SUBDIVISION REVIEW SHEET

<u>CASE NO.</u>: C8-2021-0078.1A <u>COMMISSION DATE</u>: April 19, 2022

SUBDIVISION NAME: Cearley Community Subdivision

CITY OF AUSTIN -DEVELOPMENT SERVICES DEPARTMENT SUBDIVISION APPLICATION - MASTER COMMENT REPORT

Exhibit A: Vicinity map Exhibit B: Proposed plat

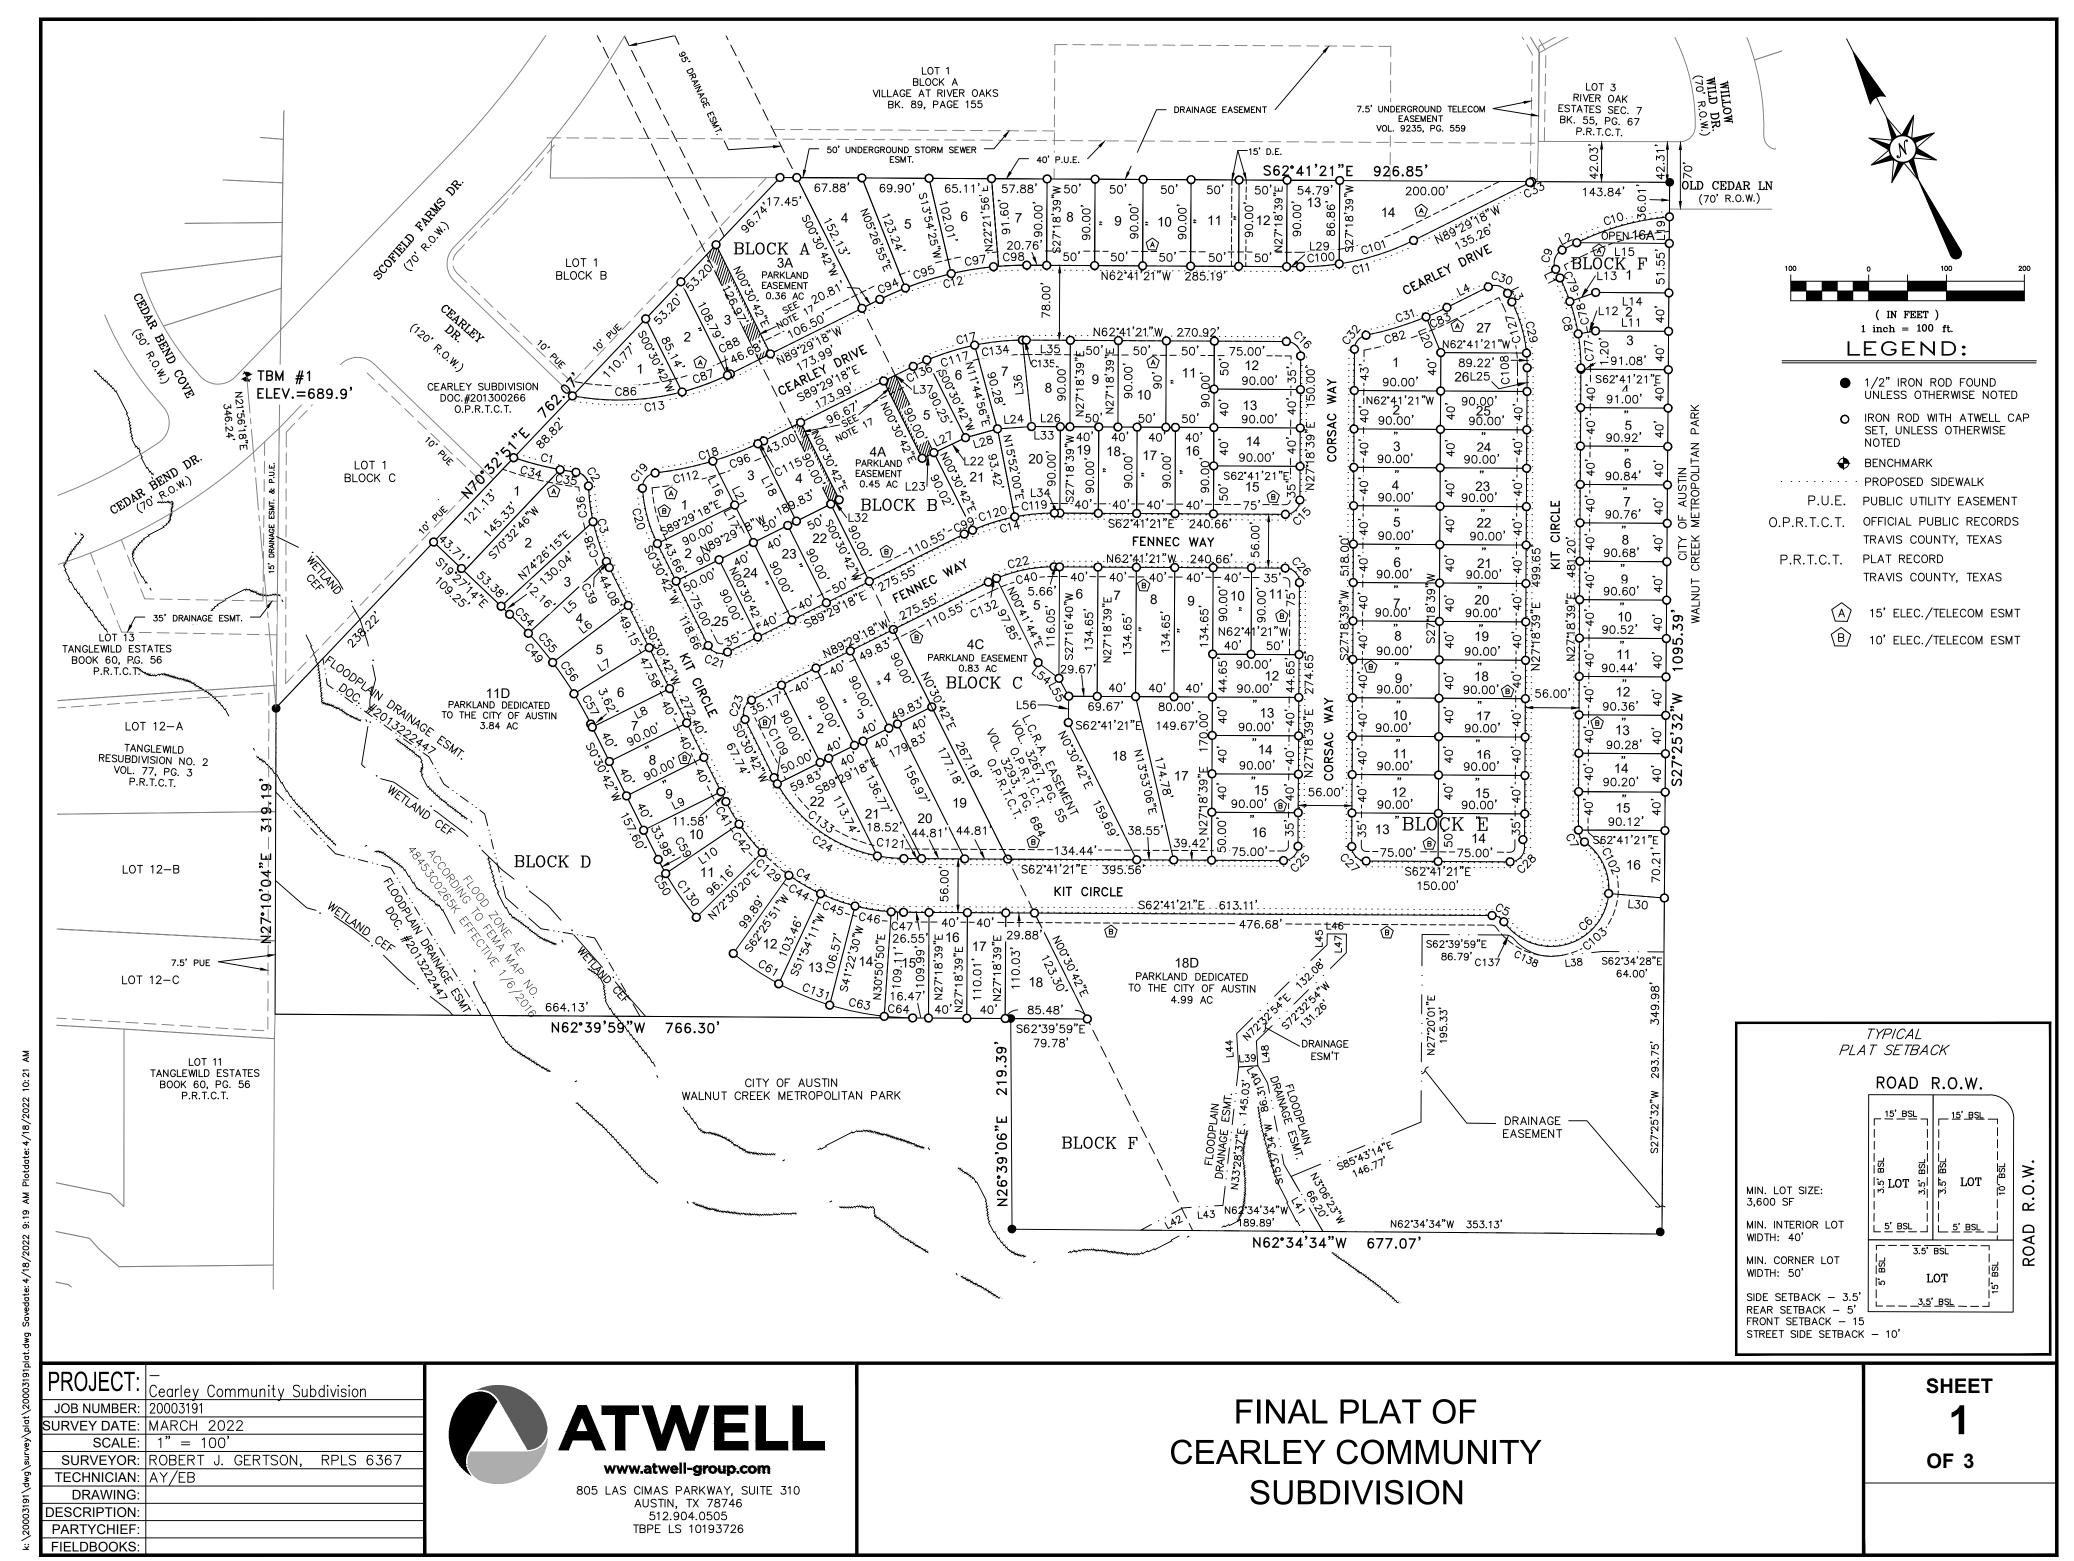
ATD 2. Sidewalks are required on both sides of Cearly Drive, Corsac Way, Fennec Way, and Kit Loop. Identify the location of the sidewalks by a dotted line on the final plat and include the sidewalk symbol within the Legend. LDC 25-6-351. TCM, 4.2.1.

U1: Please add a sidewalk symbol to the location highlighted in the image below along Cearly Drive.

- PR3. Thank you for labeling two lots as Parkland Dedicated to the City of Austin, and Lots 3A, 4A, and 4C as Park Easements.
 - A. Please remove the proposed detention pond areas from the parkland.

- U2: Calculations complete. Please update parkland acreages on plat page to match color parkland exhibit. Fiscal memo has been written and will be sent to the applicant so that fiscal can be posted prior to subdivision approval. Comment pending posting of fiscal.

U2: Please update note #18 to indicate total amount of parkland by deed and easement. My calculation is 4.83 acres.

EL 2. U2: **Comment stands.** According to 1.2.2 Exchange of 128kV Transmission Circuits of the 1997 Transmission and Communications Agreement, Austin Energy owns the west half of the transmission easement that contains AE transmission structures and circuits. Please remove parkland easements from the western half of the easement.

U2: Comment cleared.
